DevHU0144 Immingham Green Energy Terminal

Prepared for: Becky Garrett
Prepared by: Harry Robinson / Alan Philp
Date: 31st May 2024
Case Reference: DevHU0144 / AA.24.05.22
Document Reference: DevHU0144 007 TM Final
Reviewed/approved by: Terry Dale

The JSJV has reviewed IGET traffic report on behalf of National Highways and would offer the following comments.

Figure 3. Google Maps typical traffic AM peak¹

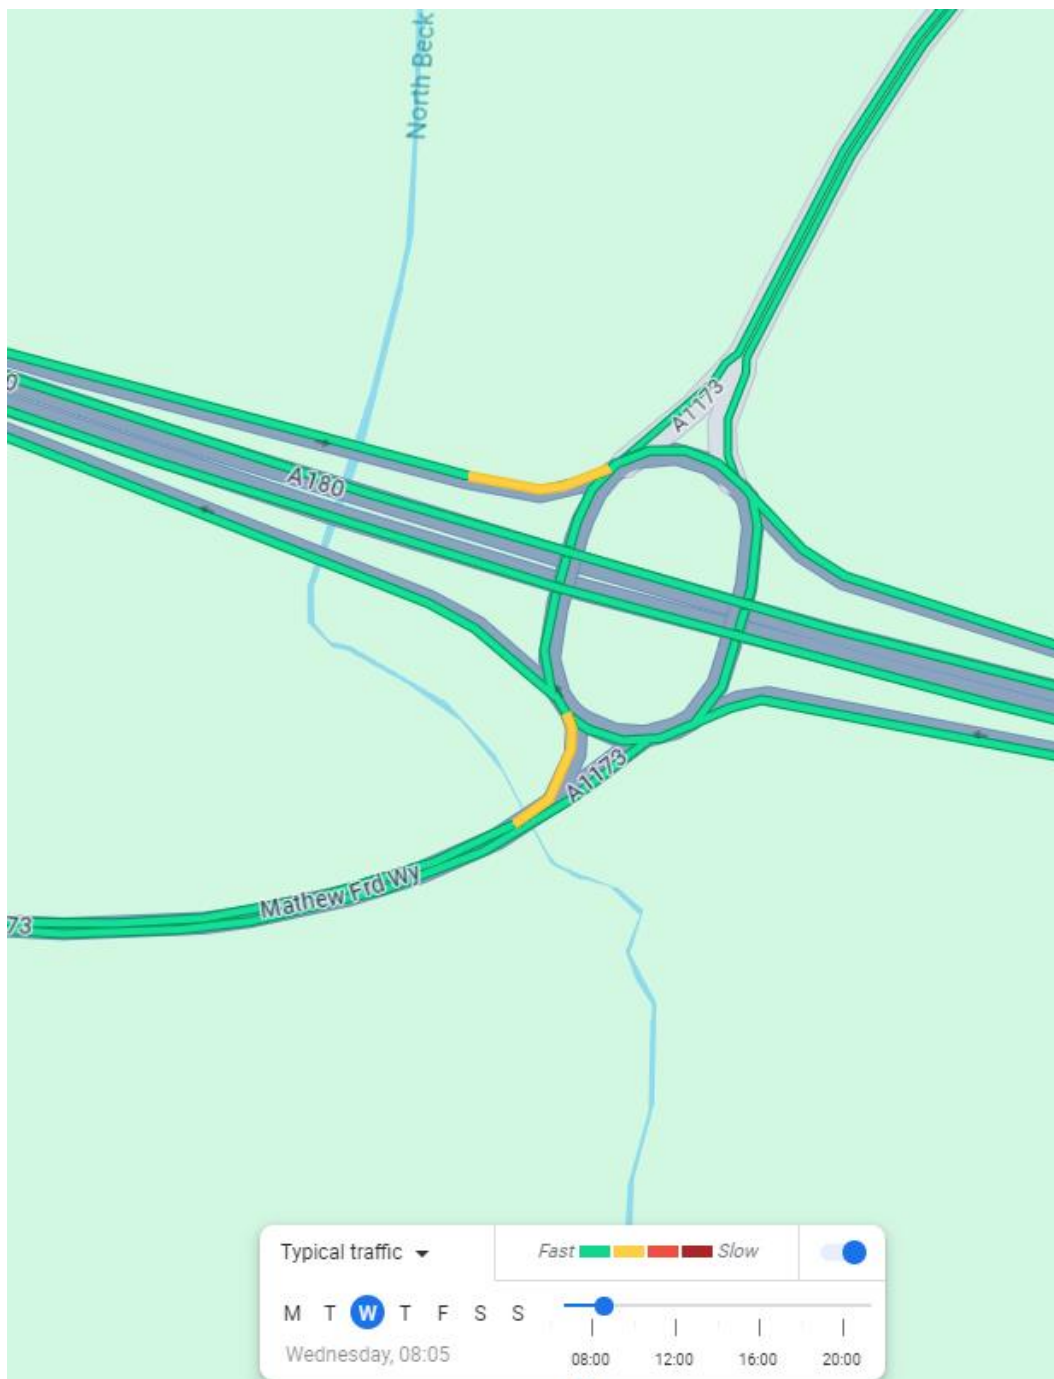
We have reviewed the performance of the junction based on typical traffic data obtained from Google Maps. It is seen that there is negligible delay experienced during the AM peak as shown in **Figure 3**. There is also negligible delay experienced during the PM peak as shown in **Figure 4**.
